369-377 Kentish Town Road

Design Statement

September 2024

This document sets out proposed design updates to the approved scheme at 369-377 Kentish Town Road. The original consent was for a seven story (G+6) building with 14 residential apartments, and Class E (retail) use at ground and basement floor. Planning permission was granted for the scheme in 2020 - application ref: 2019/0910/P.

2.5.2 Horizontal Banding Detail - Development

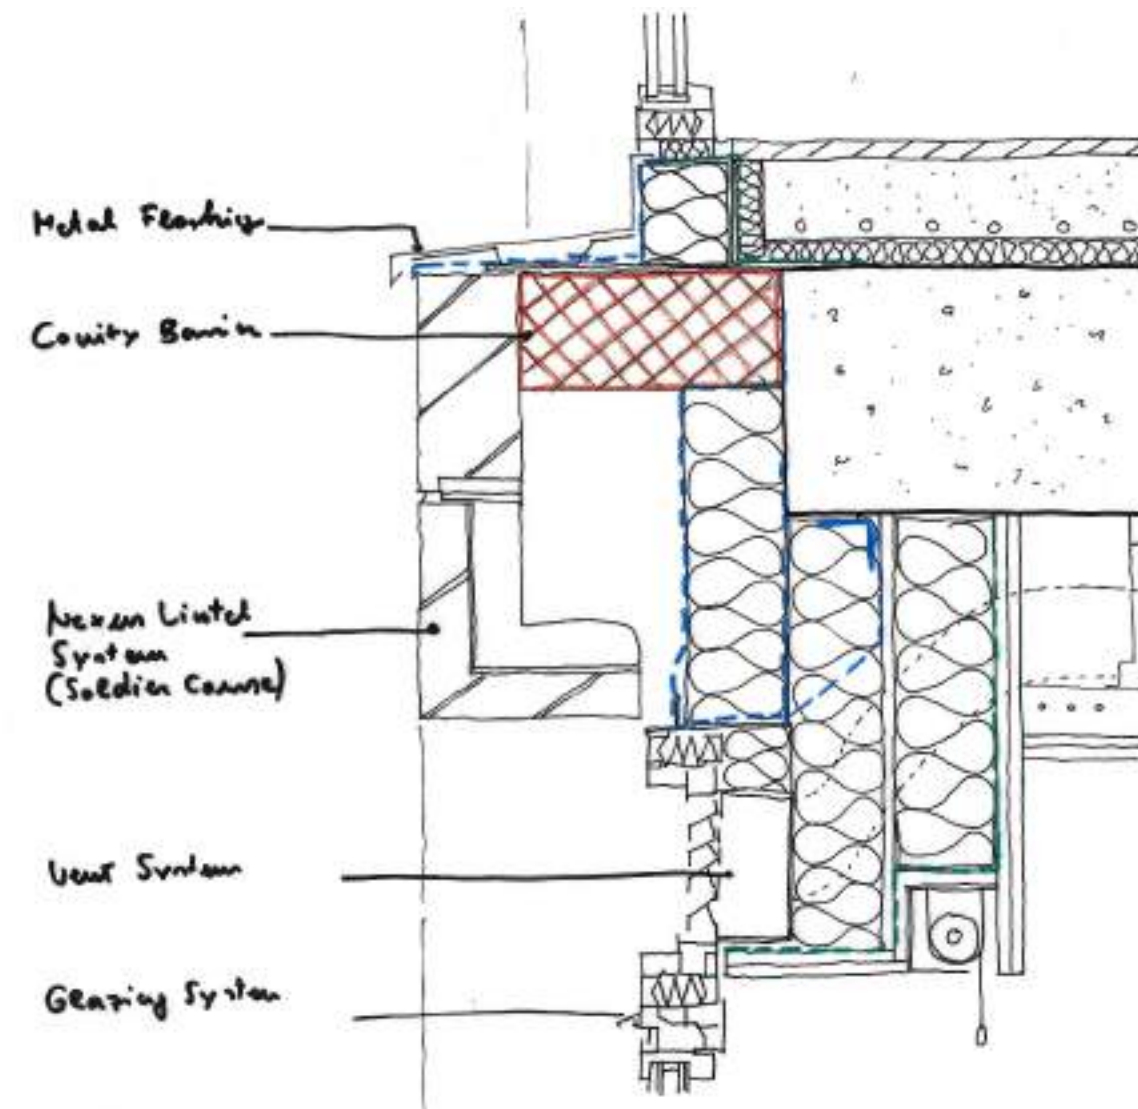
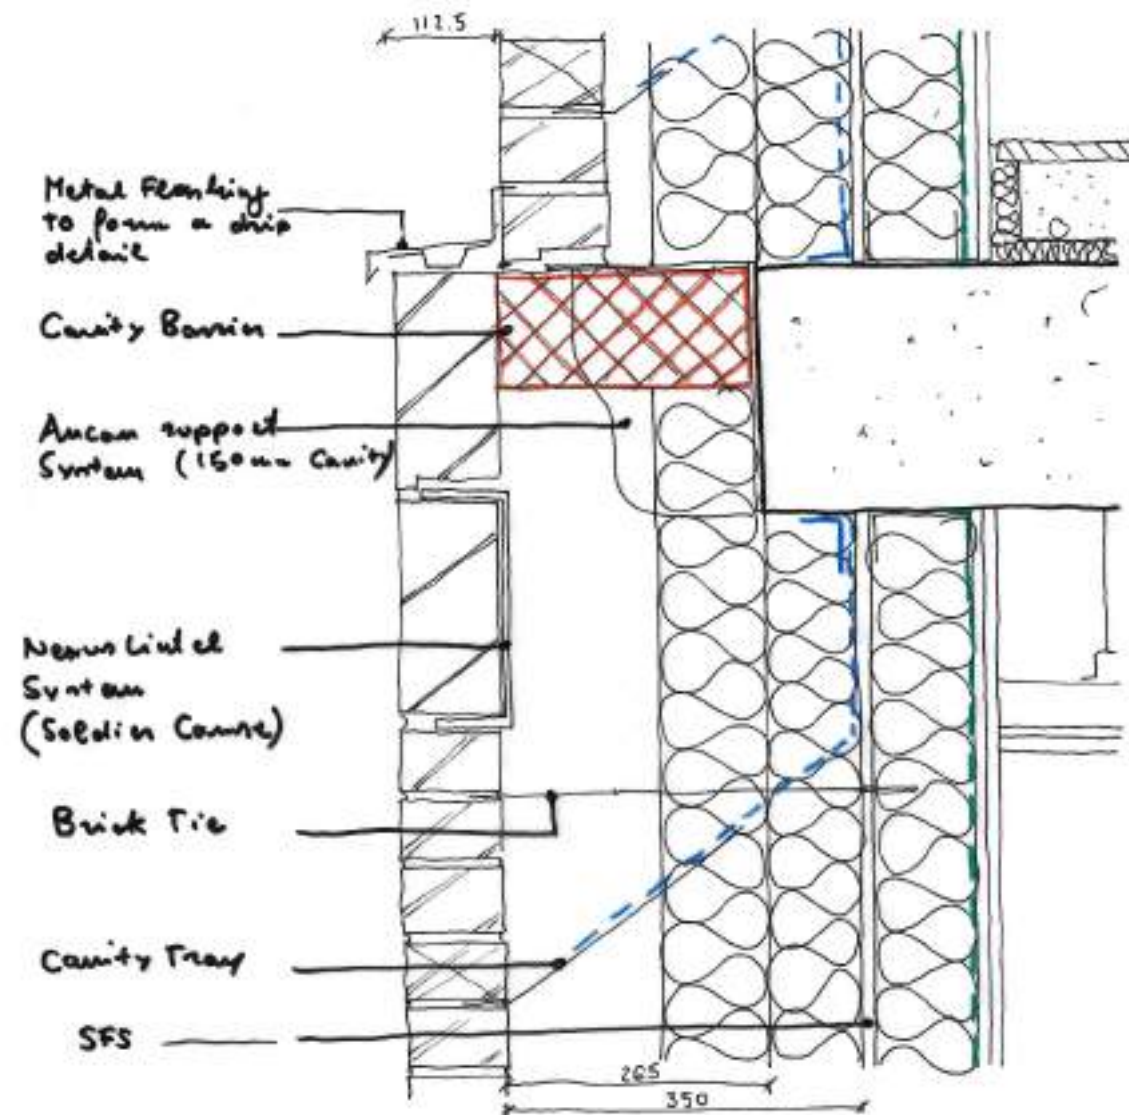
In the updated design the horizontal banding is created using a double vertical brick soldier course, supported using a concealed lintel system. There are several benefits to this approach affecting the quality of the design:

1. The issues of colour and consistency of finish quality are dealt with by changing the material to bricks, matching the rest of the facade.
2. Tolerance can be absorbed within the cavity and the soldier course can be installed to be flush with the face of the other brick walls.
3. The soldier coursing creates strong bands of vertical bricks running horizontally, which maintains the expression of horizontality - a key design element of the approved scheme - see overleaf.

Proposed Update: Recessed Panel Detail

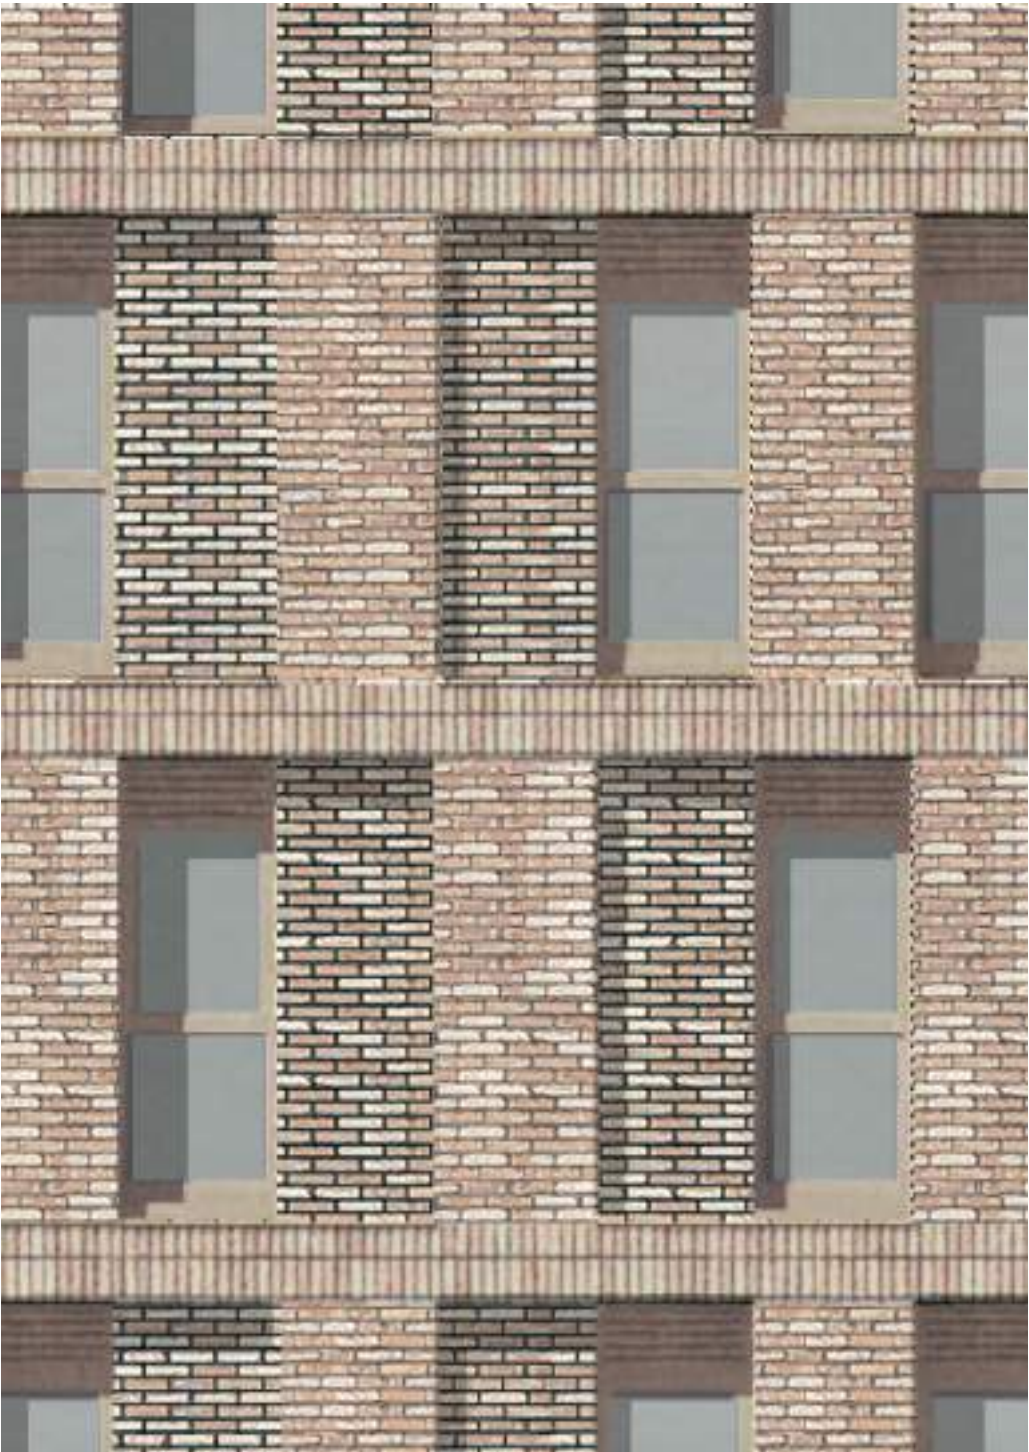
Using a racked brick finish expresses the recessed panel elements in the 'second layer' of the facade. This method uses a stretcher bond and therefore reducing brick cutting over Flemish bond with extruded headers.
